# 2020 Corvette: GM TechLink: Removal of Corvette Z51 Spoiler

## Removal of Corvette Z51 Spoiler

GM TechLink

**Fig. 15**

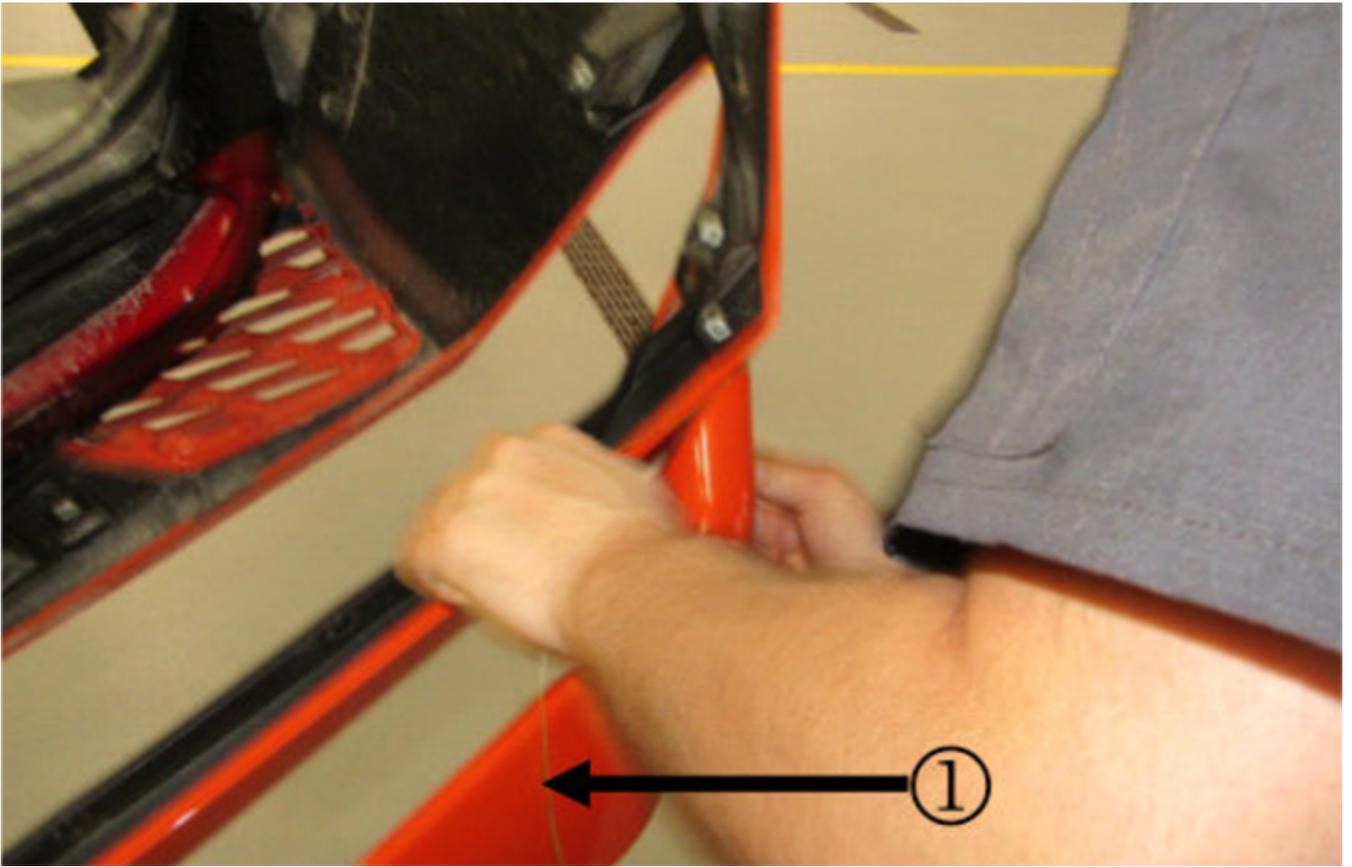
2020 Corvette Stingray models equipped with the Z51 Performance Package feature a rear spoiler that adds downforce to improve high-speed stability. (Fig. 15) If the Z51 spoiler is to be replaced with the high wing accessory spoiler, there may be some concern about applying heat to soften the two-way tape retaining the spoiler without damaging the rear fascia paint. The fascia paint may not be able to withstand high heat generated by a heat gun.

To remove the Z51 rear spoiler, it's recommended to use 50 lb. test monofilament fishing line. Position the line (Fig. 16, #1) between the spoiler and fascia and, with a sawing motion, move the fishing line through the two-way tape to remove the spoiler. Using the fishing line method will eliminate any possibility of damage to the painted fascia surface.

**Fig. 16**

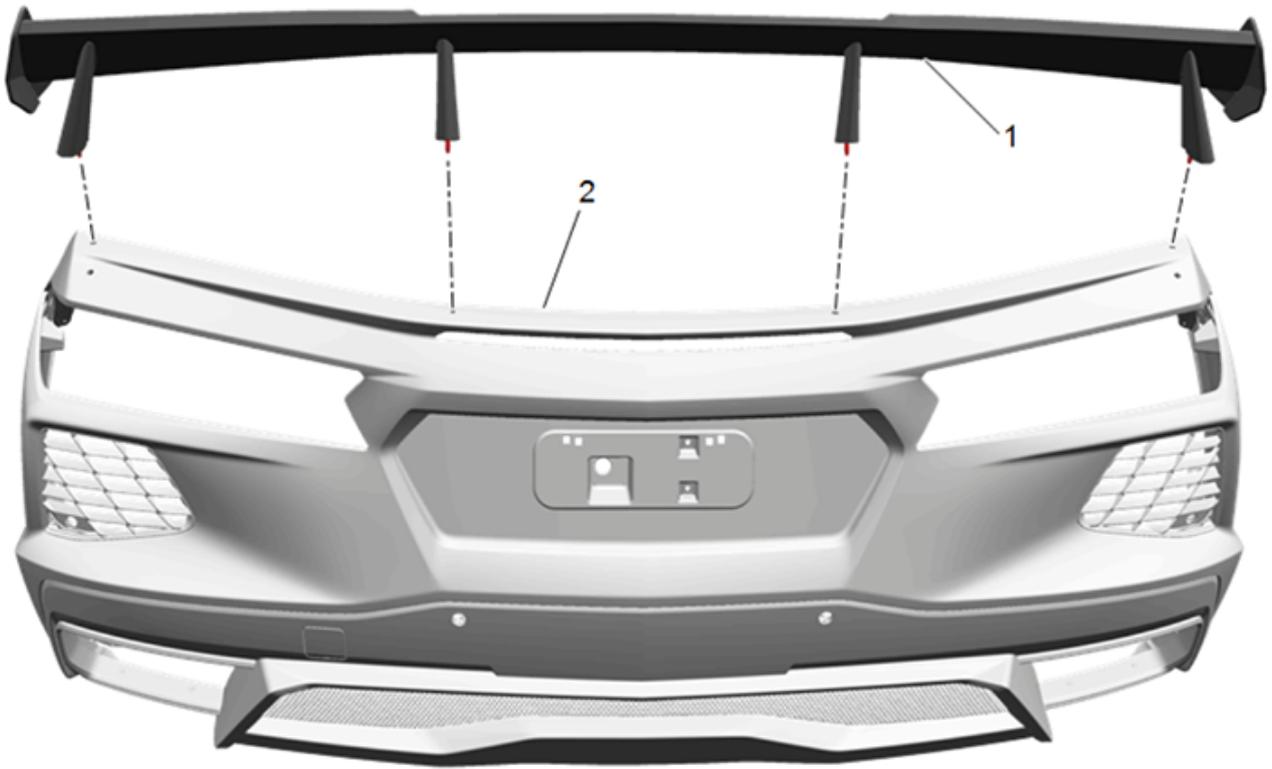
Do not use a heat gun, or attempt to pry the spoiler off the fascia with a plastic, metal or wood trim removal tool, in order to loosen the adhesive tape.

The installation instructions for Rear End Spoiler Package Installation (Fig. 17) in the Accessories Manual in the Service Information have been updated to eliminate the use of a heat gun to soften the two-way tape. Follow the updated installation instructions and do not use a heat gun during the removal process.
